PUBLIC WORKS AND GOVERNEMENT SERVICES CANADA
QUAIS DE LA REINE - RECONSTRUCTION OF WHARVES 97-98
(PROJECT NO 052833-001 & R.052834.001)

ADDENDUM NO 02

SITUATION EXISTANTE, DÉMOLITION
EXISTING ARRANGEMENT DRAWING, DEMOLITION

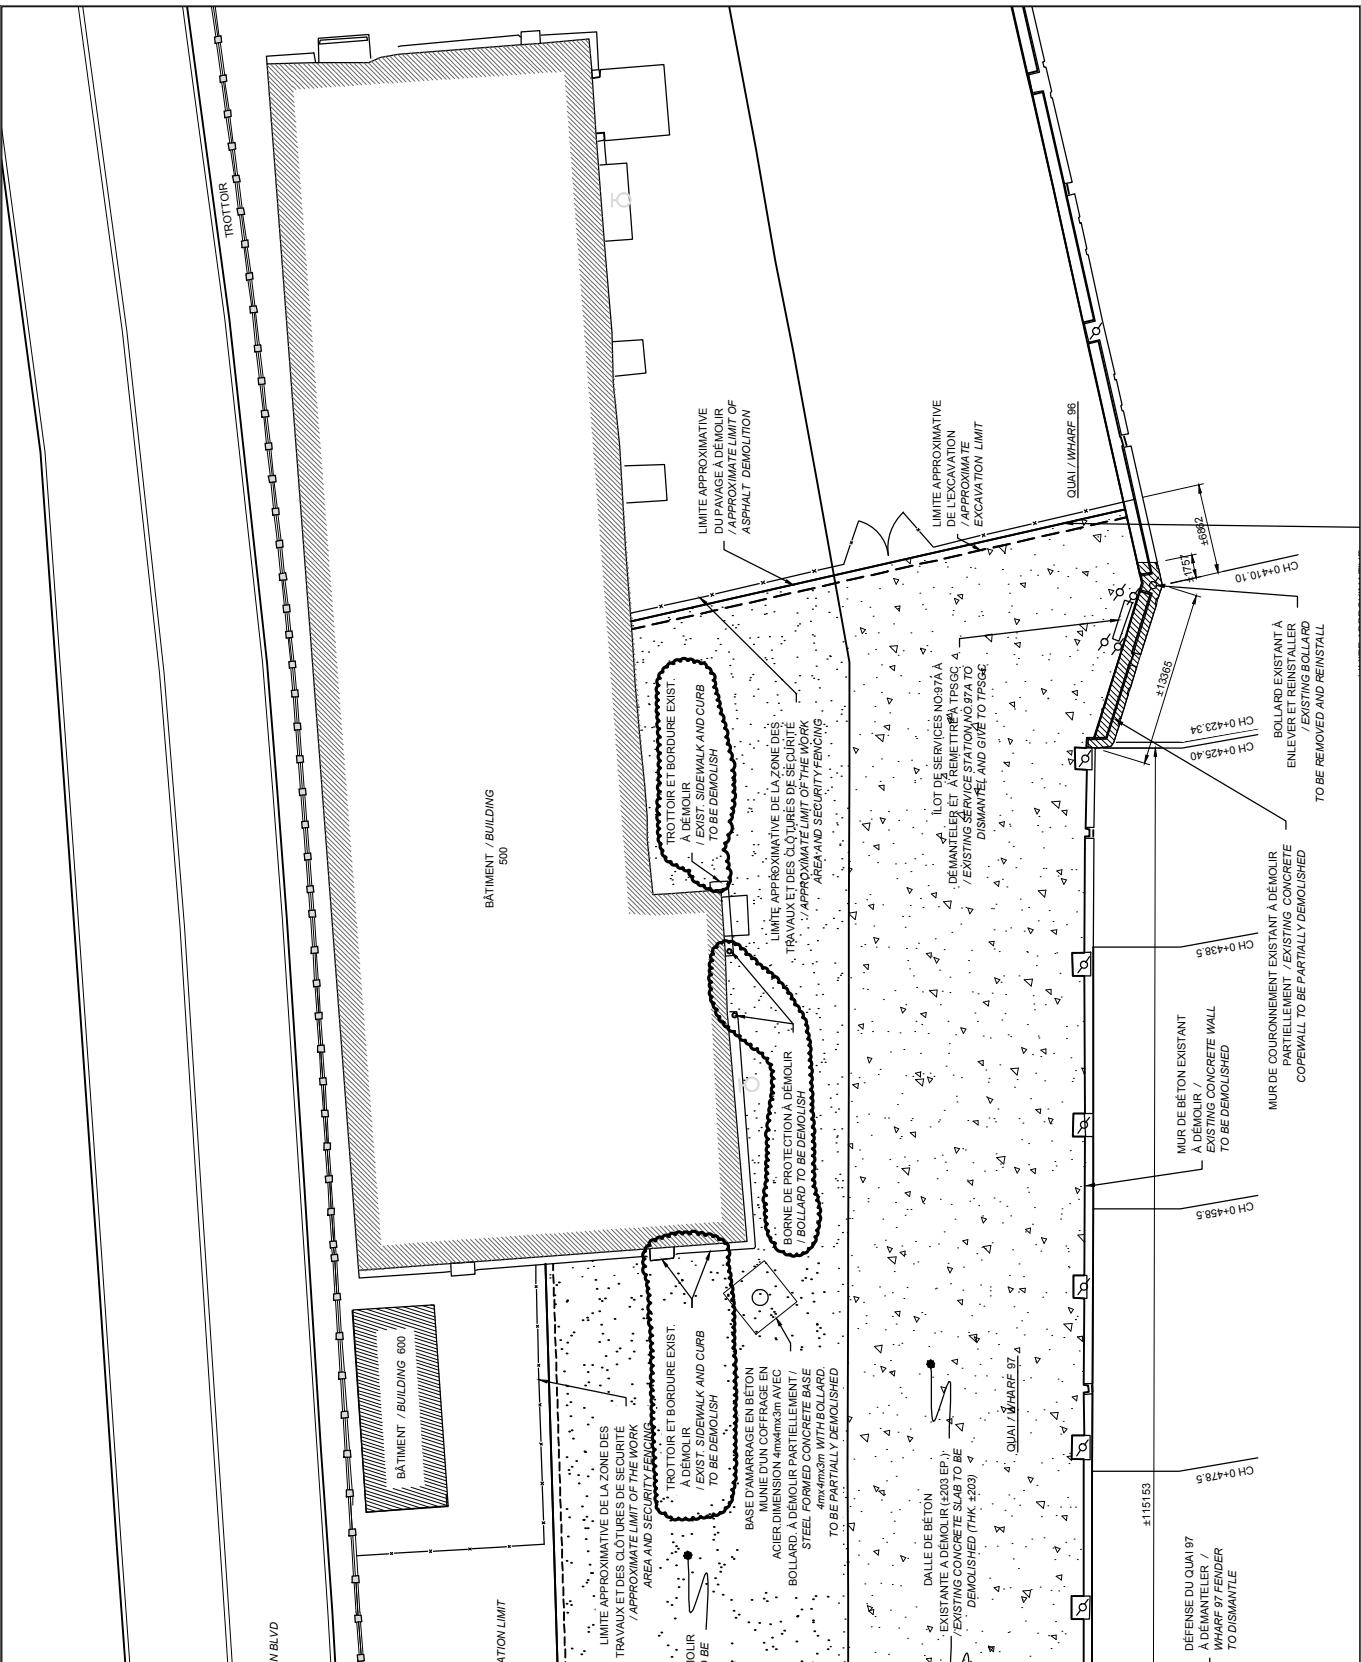
The edges, sidewalks and bollards in the work zone of buildings 500 and 900 are to be demolished.

NOUVEAU QUAI PROJETÉ,VUE EN PLAN PROJECTED NEW LAYOUT,PLAN VIEW

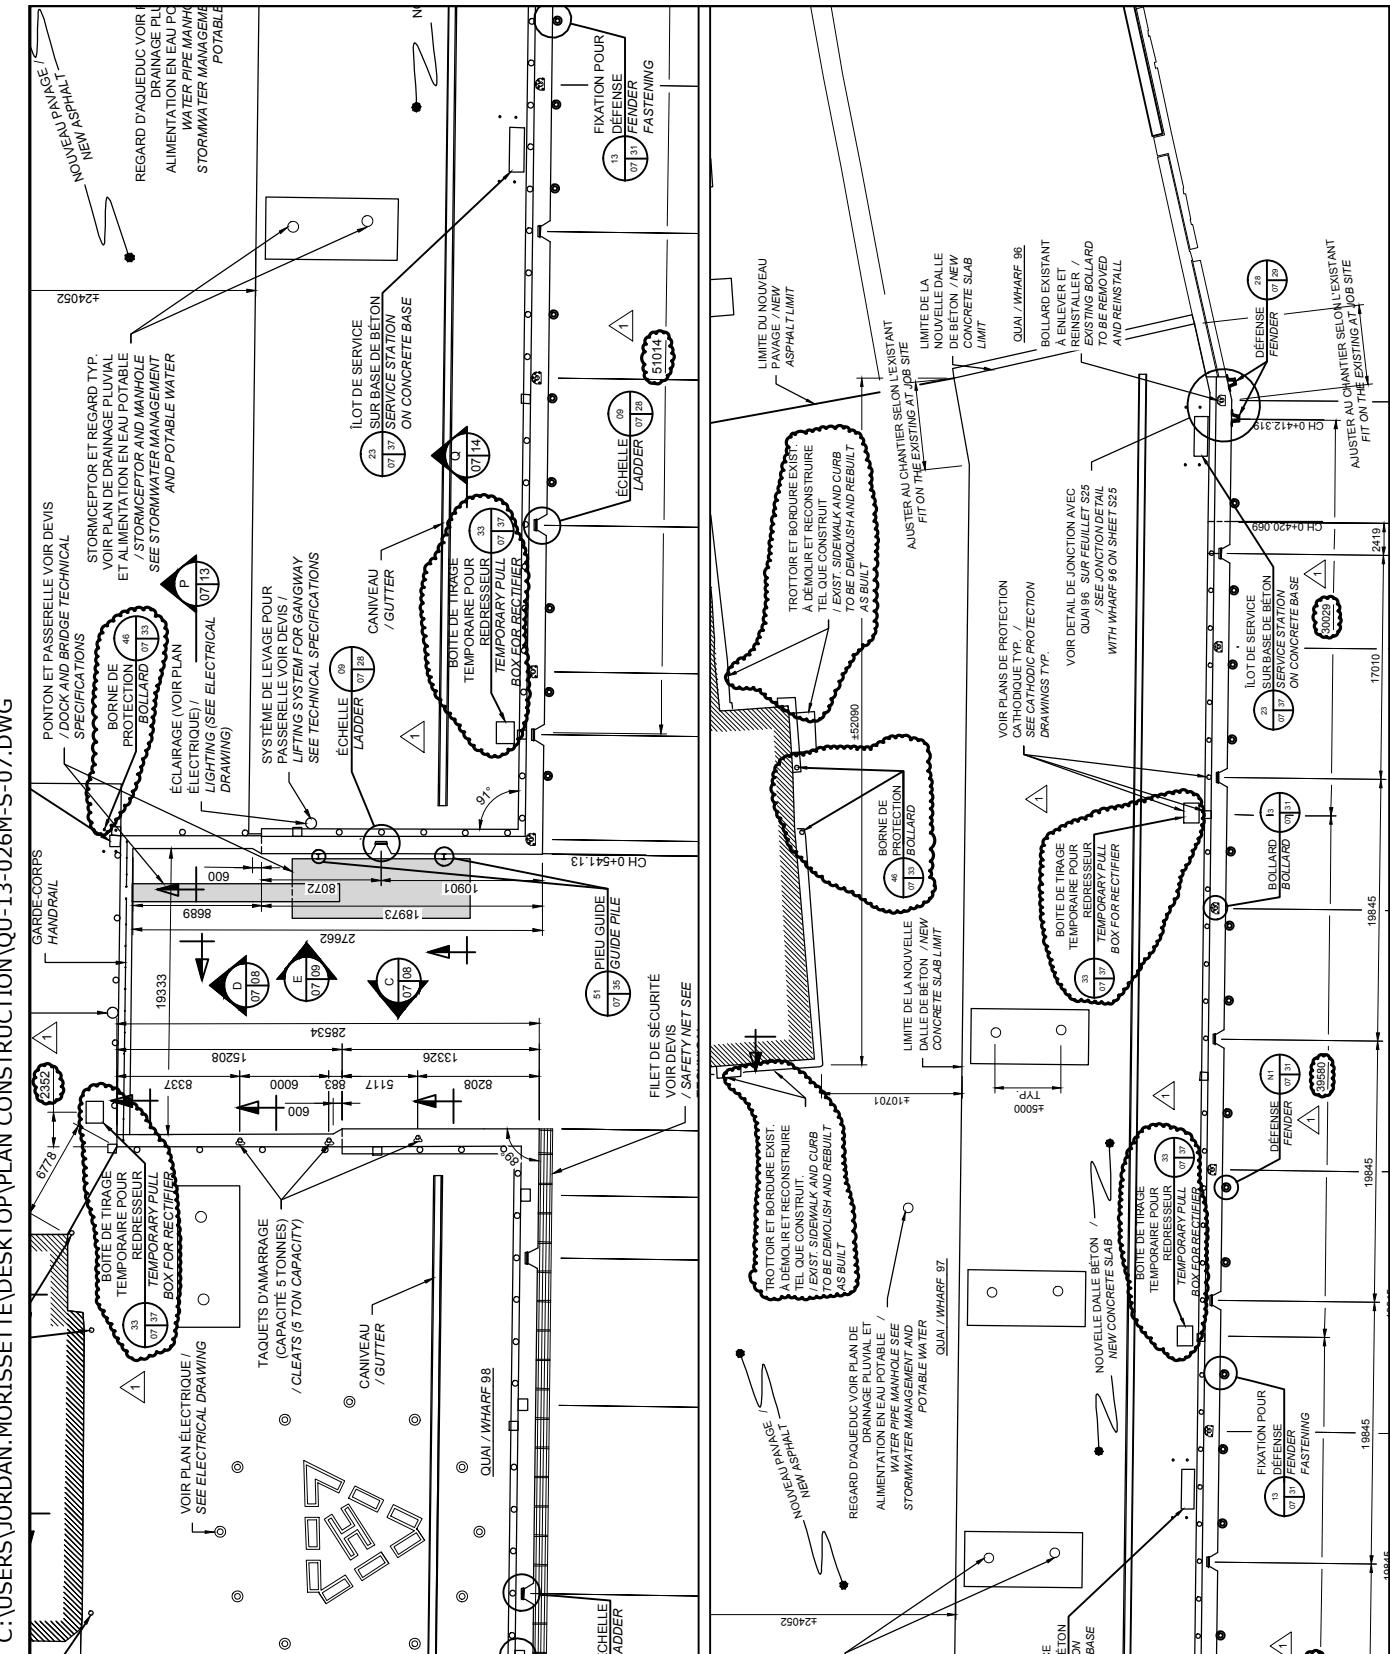
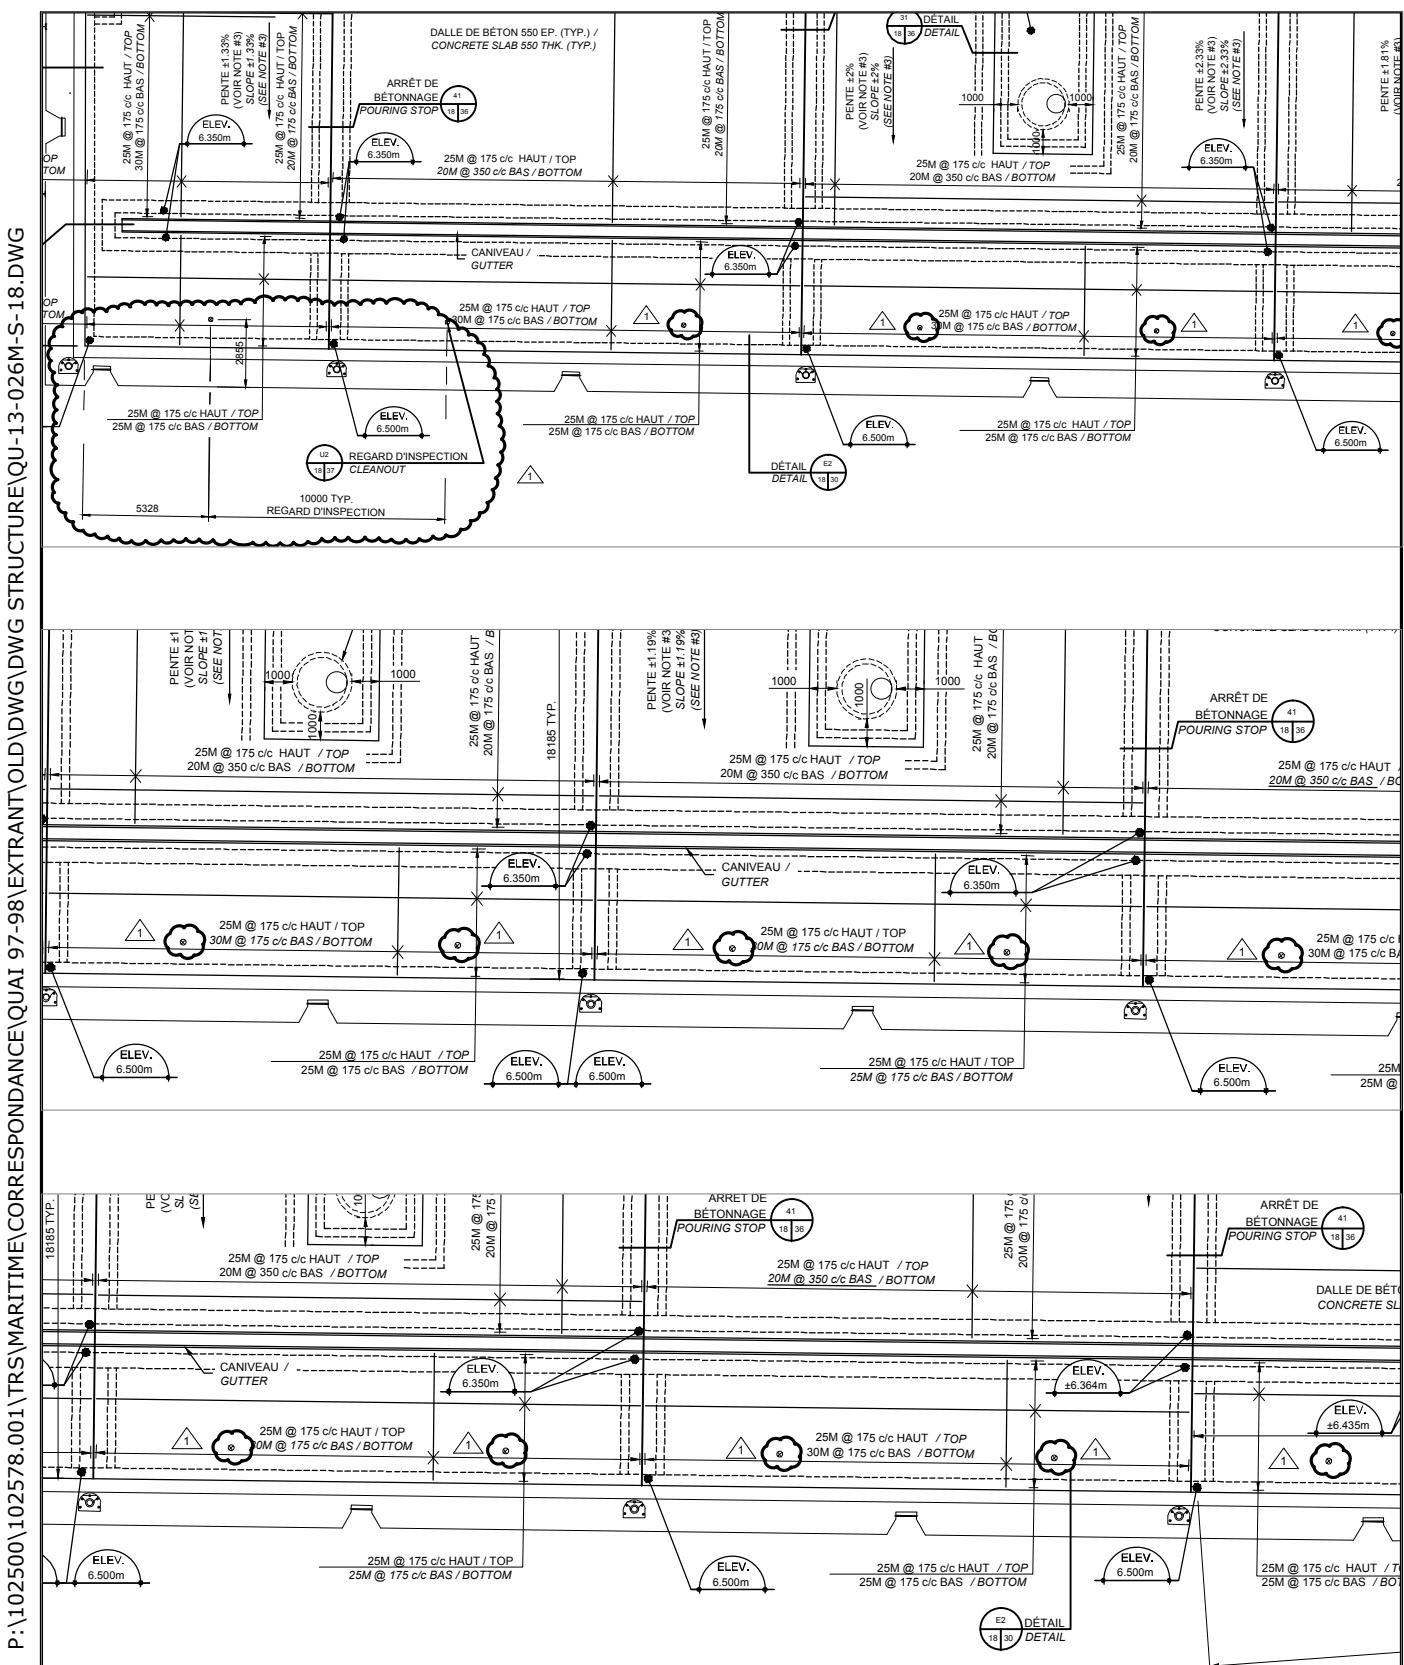
Concrete bases for the rectifiers are removed. They are replaced by temporary pull boxes.

The location and distance between the temporary pull boxes are specified.

Some design criterion regarding the permanent wharf are added.

Bollards and sidewalks, in the sectors of buildings 500 and 900, are to be reconstructed as the present ones were. The bollards which are set up in concrete must be added in accordance to the indications.

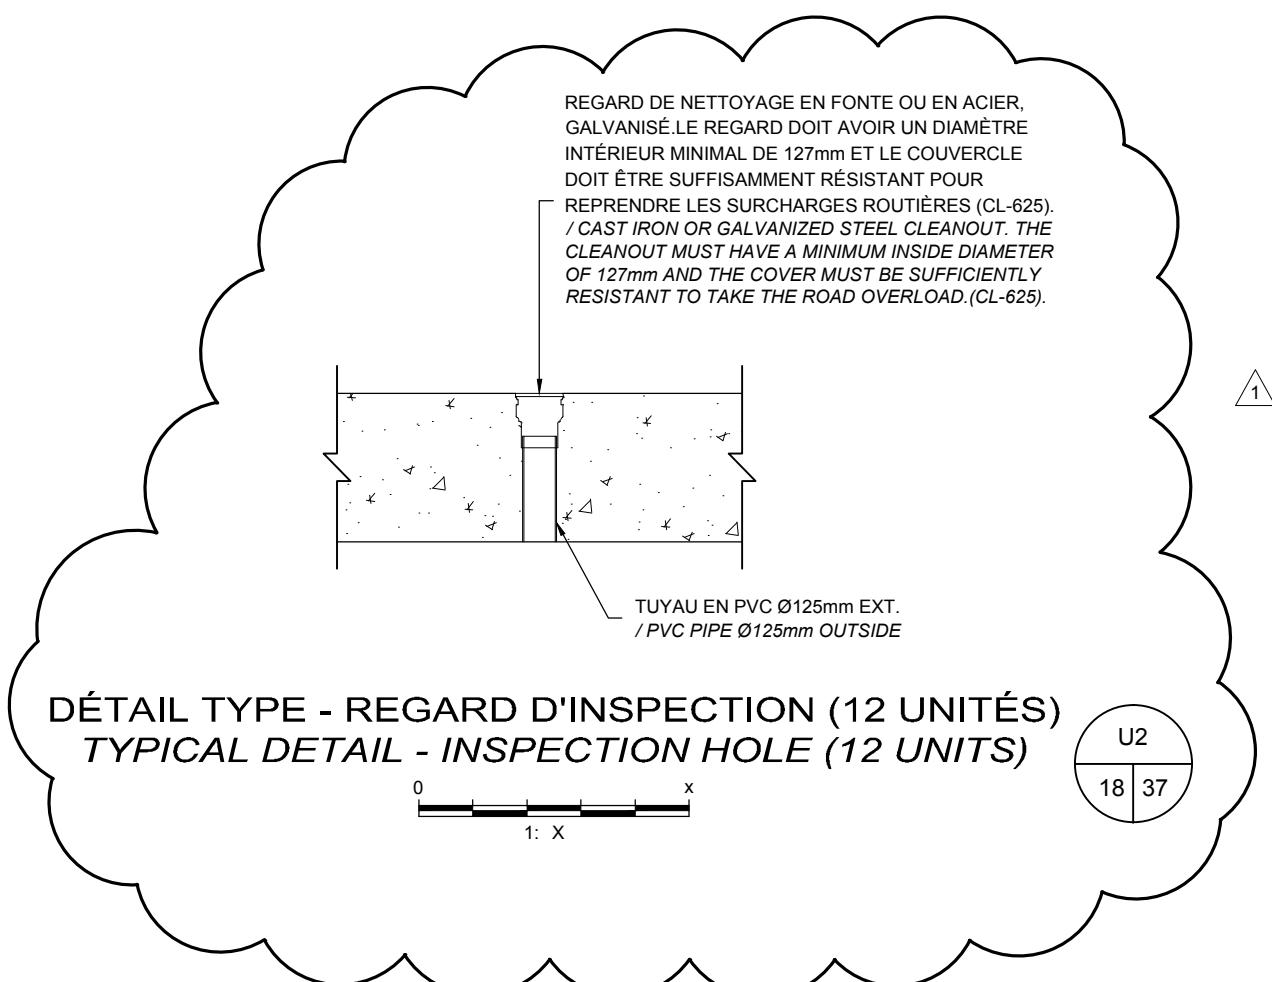
Monitoring wells are added to the concrete slab (12 in total). The location and distance between wells are specified.

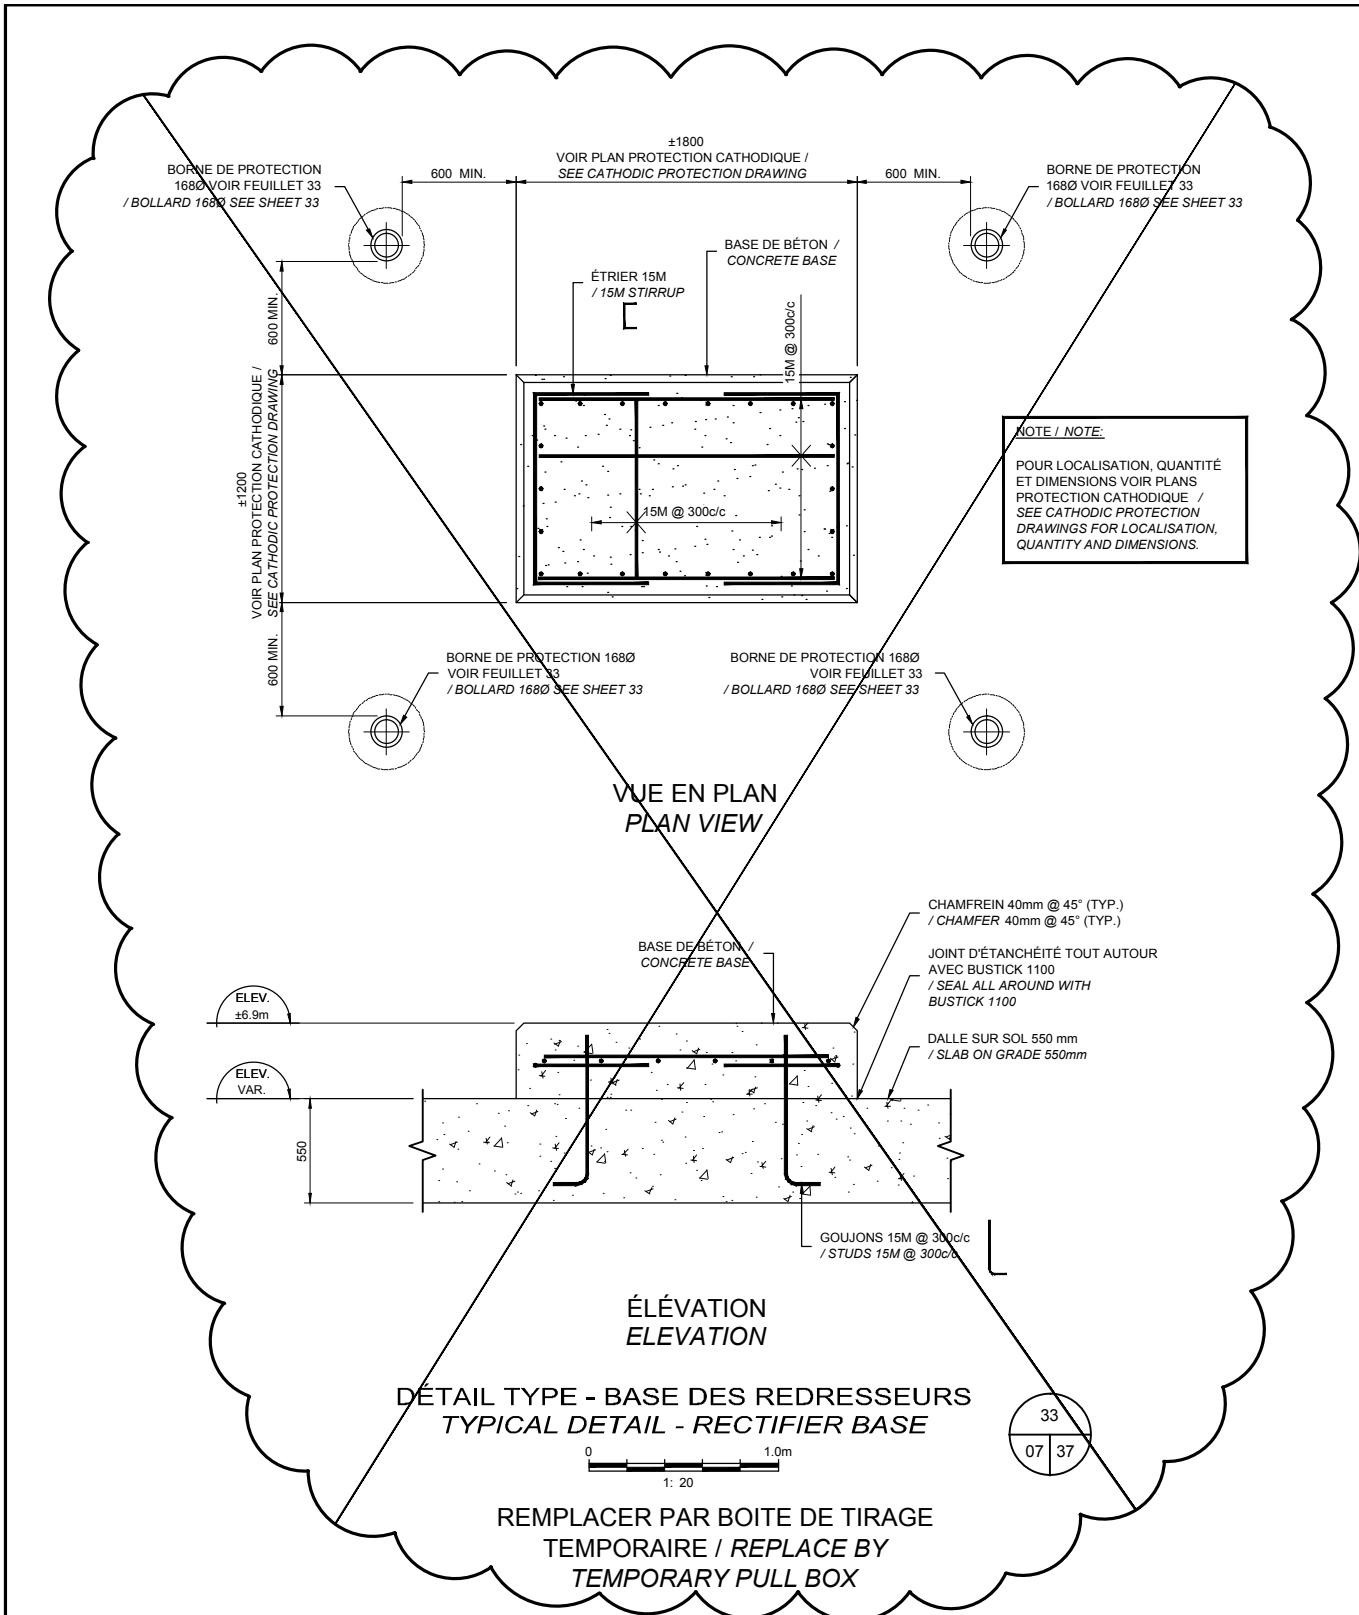
Concrete rectifiers bases are removed. The bases of service islands are maintained.

Details of cleanouts are added.
